## SIB 64 01 26

### RECALL 26V-096: CHECK AND REROUTE COCKPIT WIRING HARNESS

This Service Information Bulletin (Revision 2) replaces SI B64 01 26 **dated February 2026**.

## SIB 64 02 26

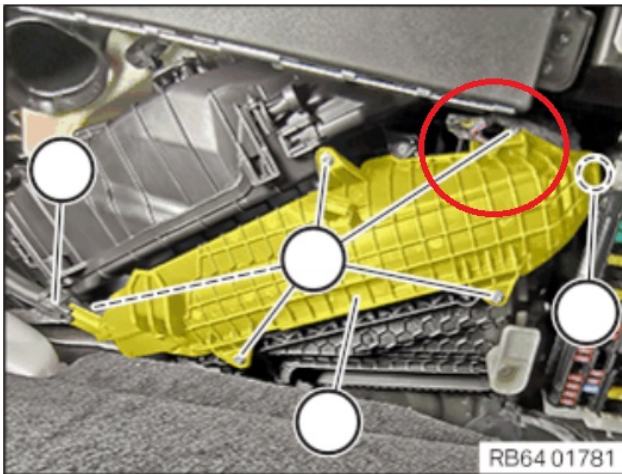
Inspect the harness routing, and add a retainer to the harness (arrow) to prevent it being pinched under the air filter plastic cover.

Check the vehicle wiring harness routing (circled) to ensure it is not pinched by the plastic cover over the filter.

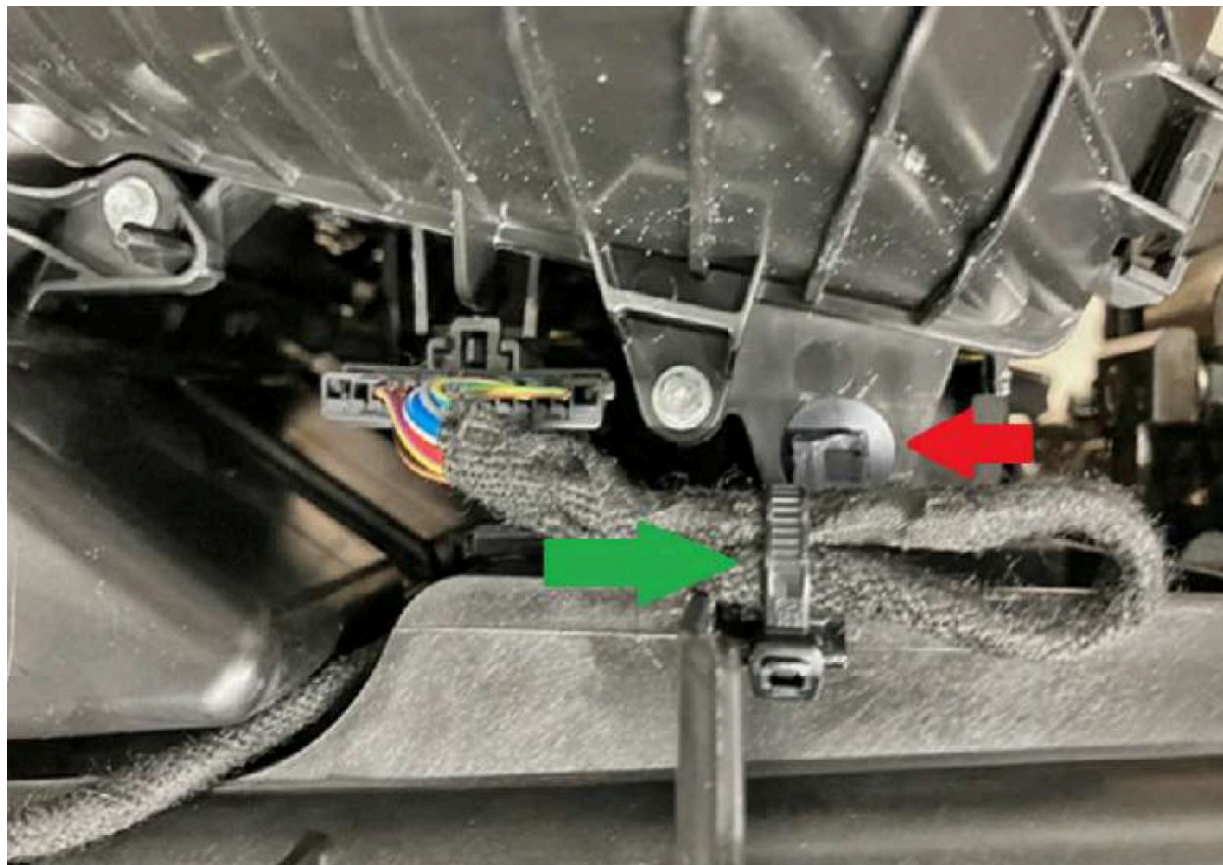
The original harness retainer must be disconnected. This is shown by the red arrow below. It can be left clipped into vehicle but must be disconnected from harness for strain relief.

Install a new harness retainer with cable strap on the instrument panel wiring harness, see green arrow.

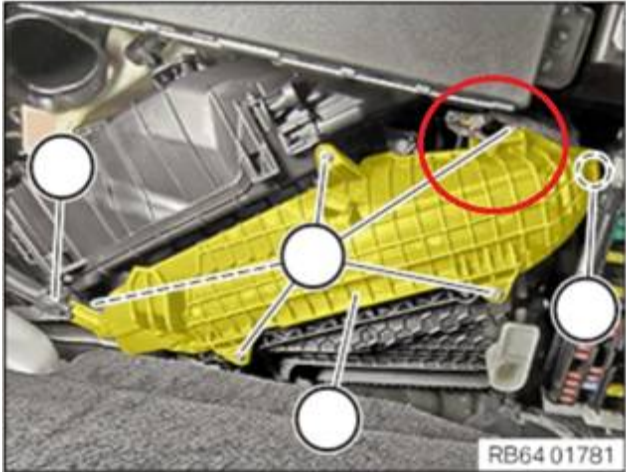
Inspect the harness routing and add a retainer to the harness (arrow) to prevent it being pinched under the air filter plastic cover.

Check the vehicle wiring harness routing (circled) to ensure it is not pinched by the plastic cover over the filter.

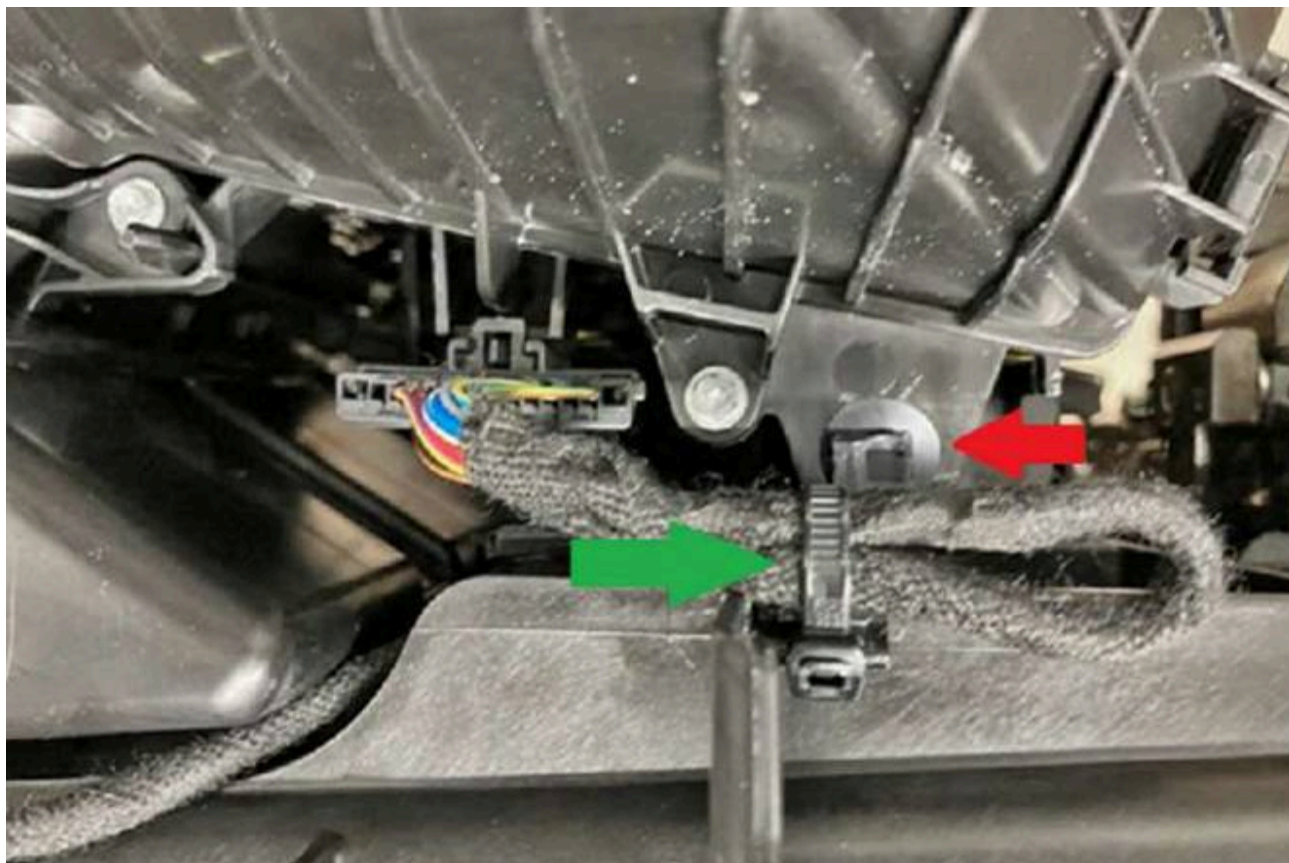
The original harness retainer must be disconnected. This is shown by the red arrow below. It can be left clipped into vehicle but must be disconnected from harness for strain relief.

Install a new harness retainer with cable strap on the instrument panel wiring harness, see green arrow.
